Access Compliance Report

Public Rights-of-Way

Intersection ID: 45240	Main Street: BEGONIA_DR	Cross Street: BLAZE_MANOR_LN	Location: SW
ADA ID: D95A16D4EE40	Ramp Type: PerpDiag	Initial Pass/Fail: Pass	Overall Compliance: No
		Severity Score: 12.5

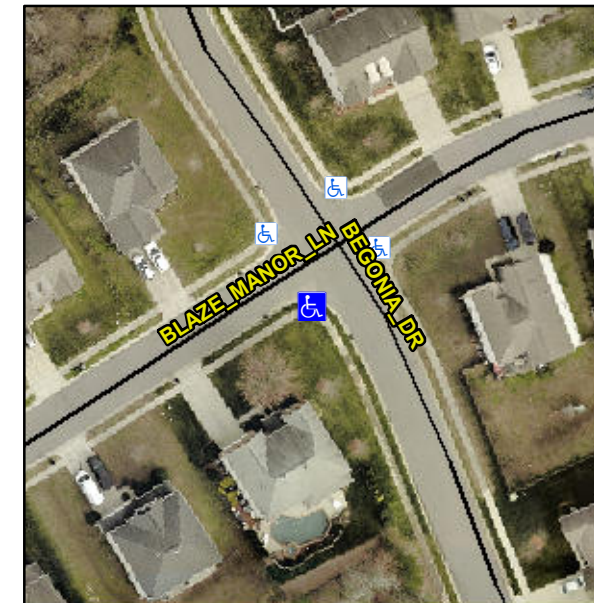
Not Found, R304.2.1, R302.7, R302.7.2, R304.5.4

Compliance	Description	Data	Compliance	Description	Data
N/A	Ramp Length (in)	48.0	Yes	Ramp Slope (%)	8.2
Yes	Ramp Width (in)	48.0	Yes	Ramp XSlope (%)	1.4
N/A	Flare Type LT	Sloped	N/A	Flare Type RT	N/A
N/A	Flare Slope LT (%)	6.1	N/A	Flare Slope RT (%)	4.2
N/A	Flare Traversable LT?	No	N/A	Flare Traversable RT?	No
No	Landing Length (in)	46.5	Yes	DWS Provided?	Yes
Yes	Landing Width (in)	48.0	Yes	DWS Contrast?	Yes
Yes	Landing Slope (%)	1.5	Yes	DWS Length (in)	24.5
Yes	Landing X Slope (%)	0.9	Yes	DWS Full Width?	Yes
N/A	Landing Curb? (Y/N)	No	Yes	DWS Offset (in)	1.5
N/A	Shared Landing?	No			
No	Gutter Ponding?	Yes	No	Gutter Slope (%)	12.6
No	Gutter Lip Ht (in)	0.5	Yes	Gutter X Slope (%)	0.1
N/A	Painted X Walk1?	No	N/A	Painted X Walk2?	No
	X Walk 1 Direction	To NE		X Walk 2 Direction	To N
N/A	X Walk 1 Width (in)	N/A	N/A	X Walk 2 Width (in)	N/A
	X Walk 1 Slope (%)	0.7		X Walk 2 Slope (%)	0.5
	X Walk 1 X Slope (%)	0.9		X Walk 2 X Slope (%)	0.9

Remove & Replace Curb Ramp With Two New Directional Ramps or Equivalent. Remove & Replace Gutter.
